Technical Service Bulletin

MODEL(S) AFFECTED: B5 propel, B7, T300/e propel, T500/e, T600/e, SpeedGleam 5 propel, SpeedGleam 7, Speed Scrub 300 propel and Speed Scrub 500
N. America models manufactured before April 12, 2021.

SUBJECT: Speed Control potentiometer failure. Over time, under normal operating use, the potentiometer may exhibit a brief open-circuit condition and cause a propel fault. The detected fault will automatically put the i-Drive in the slow, safe mode or even cause complete propel failure. A simple key-cycle may clear the fault temporally, however the fault can reoccur when adjusting speed dial.

New Replacement Potentiometer p/n 1256757

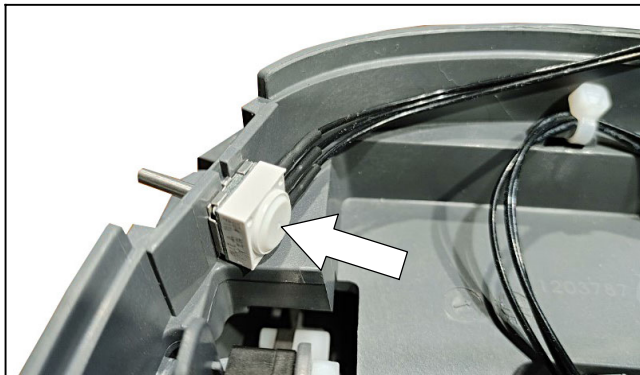
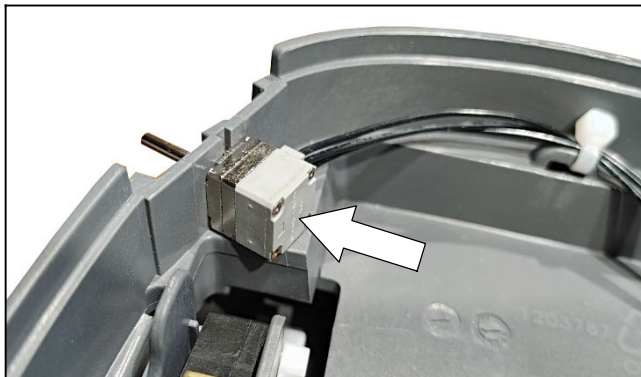
The new potentiometer is a direct replacement and does not require any specific installation instructions. To identify the difference between the previous potentiometers, the body on the new potentiometer is thinner.

PURPOSE: To repair potentiometer, order replacement potentiometer (p/n 1256757). The new potentiometer is designed with a ceramic-based resistance element for long term durability. It's also designed without speed setting detents, therefore the speed control dial will feel different to the operator.
